IREDELL COUNTY HEALTH DEPARTMENT

IMPROVEMENT PERMIT / AUTHORIZATION TO CONSTRUCT / OPERATION PERMIT / EXISTING SYSTEM INSPECTION

PERMIT# 145583 PIN# 4746261106 DATE 3-12-08

SUBDIVISION SHADOW WOOD BLOCK / SECTION ____ LOT 16 LOT AREA 1.541AC SITE CLASS. PS DESIGN FLOW 360 L.T.A.R. .25

AS BUILT SKETCH Lines Are 5' OFF U/S

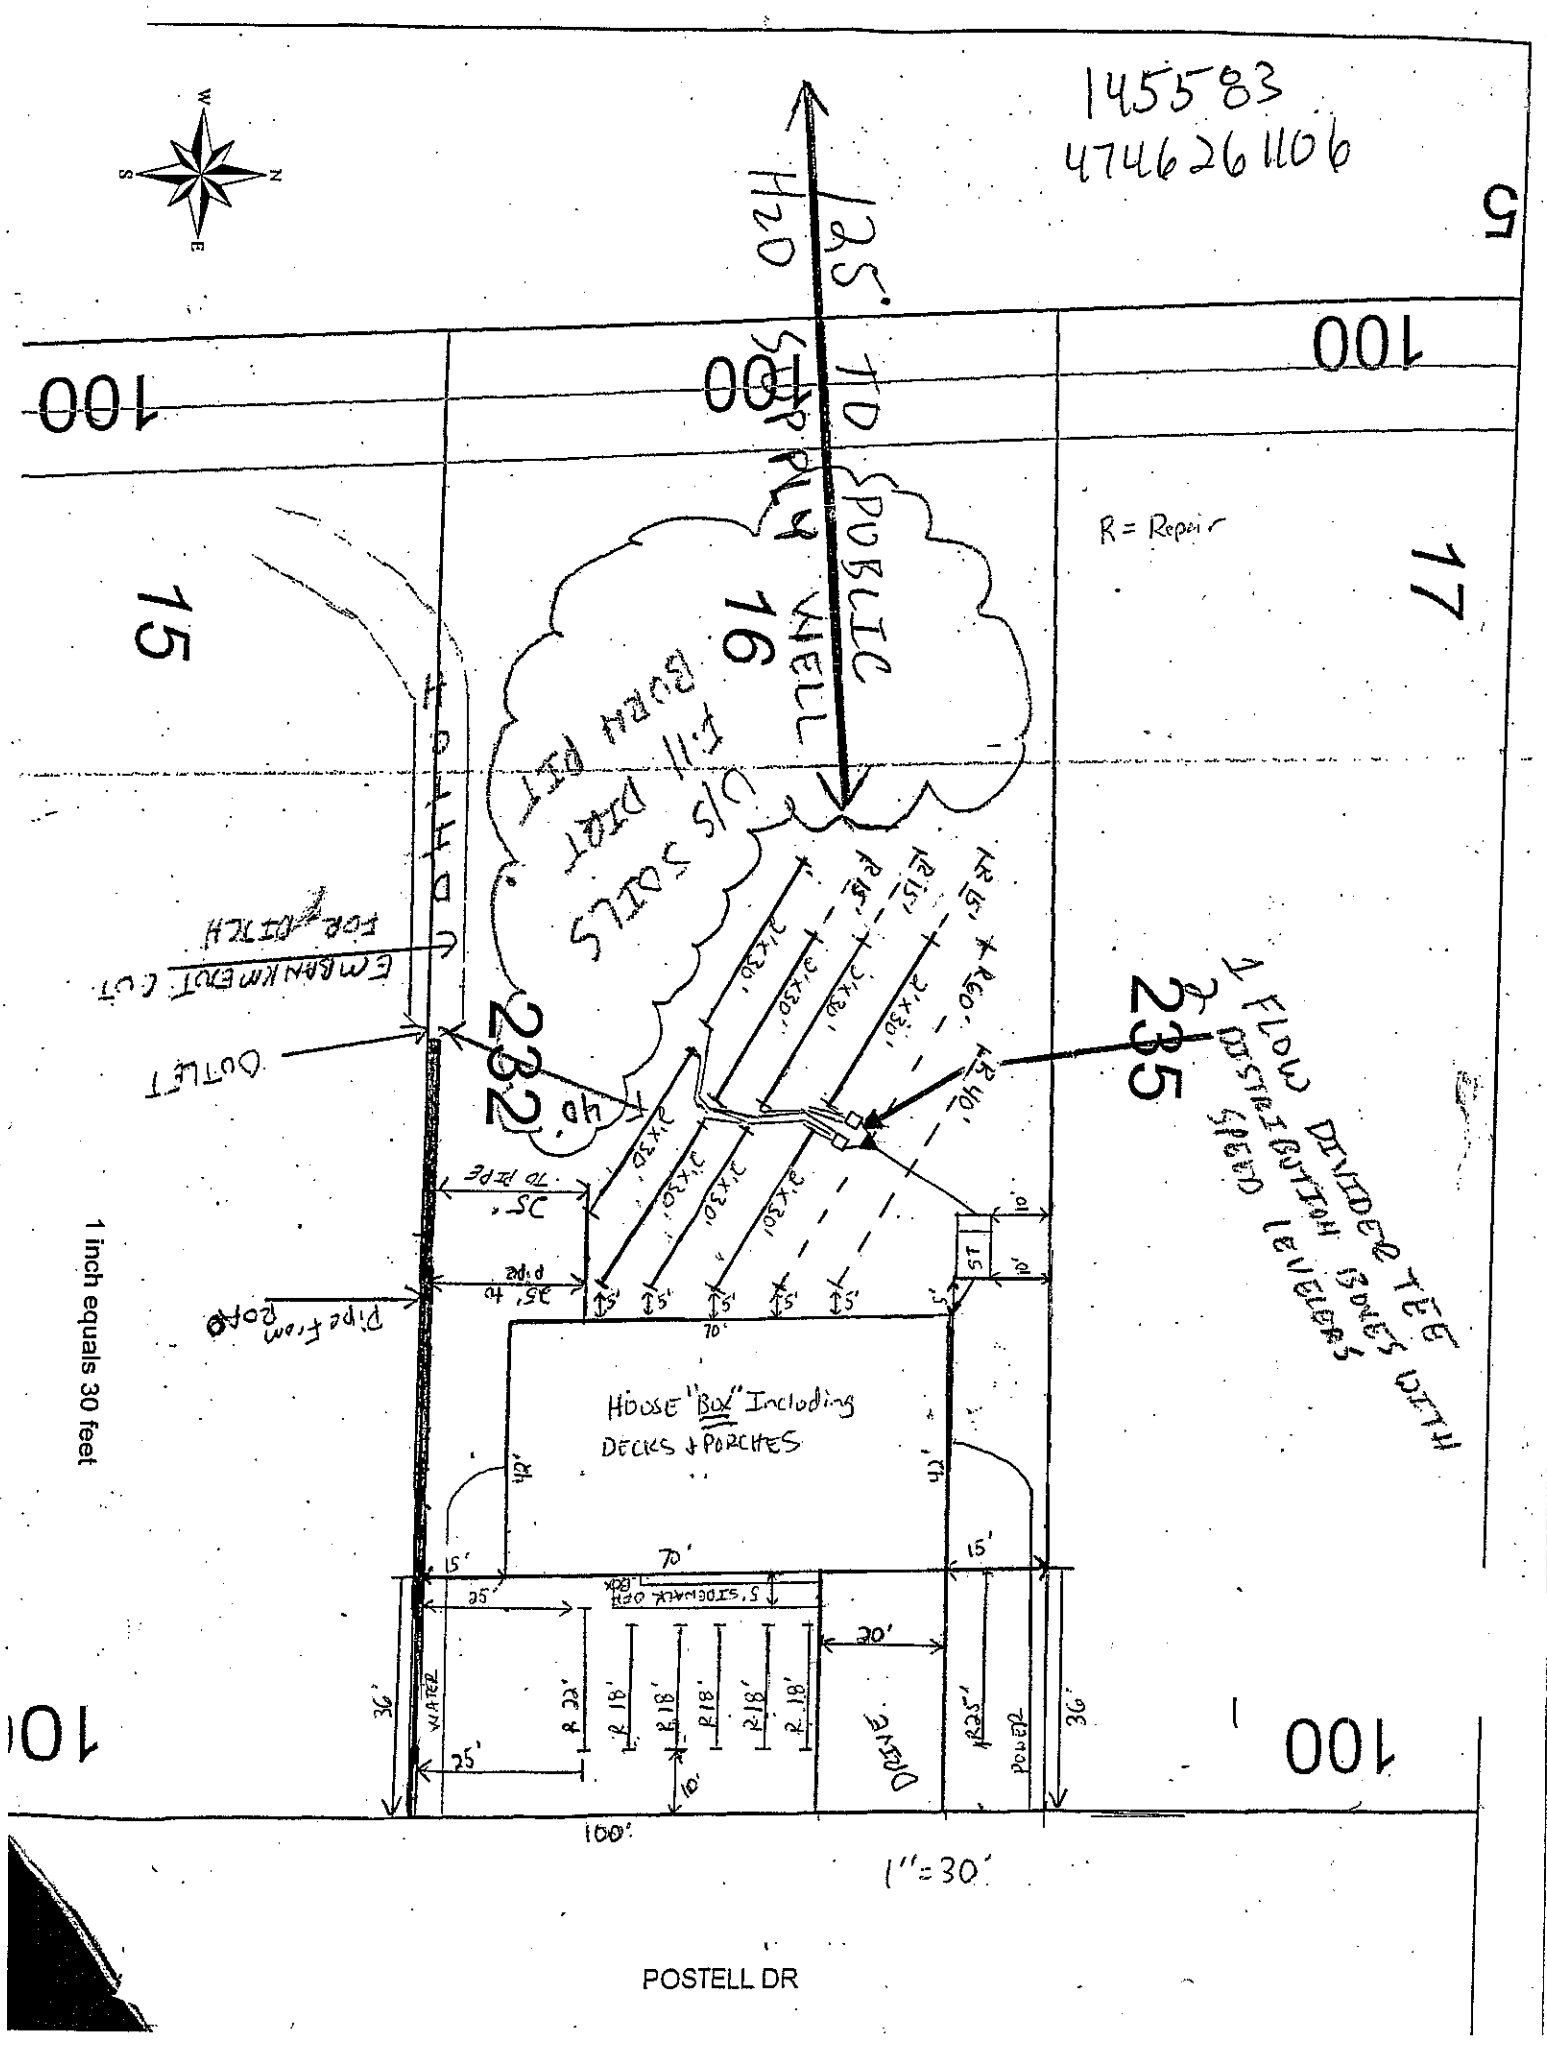
Comments/Conditions: (1) Keep Stubout High Enough That Gravity Fall CAN BE MAINTAINED, IF NOT PUMP WILL BE REQUIRED. (2) House AND SYSTEM FLAGGED OUT Completely. (3) INSTALL ONLY

Comments/Conditions: FLOW DIVIDER TEE AND 2 Distribution BOXES WITH SPEED LEVELERS AS DRAWN. (4) HOUSE BOX IS Completely MAXIMIZED AND MUST INCLUDE ALL DECKS AND PORCHES. (5) NO ROOM TO EXPAND HOUSE OR SYSTEM.

CHARACTERISTICS. (6) IF GARAGE EXTENDS TO BACK OF HOME THEN THE STUBOUT WILL HAVE TO BE THRU SLAB AS DRAWN.

(3) 3/1/10 Garage extends 2' into driveway drawn on permit. Kept concrete edge at 3.5' from P/L as drawn. BACK OF House in same location. Septic in front of BACK OF Home will be unaffected by 2' Garage change. Loque Cook RS 3-1-10

* 10-10-10 House kept 36' from road not P/L. Drawing revised with less repair in front yard and more repair area in back yard per supervisor construction. Builder approved changes * Clay Gentry Signature DATE
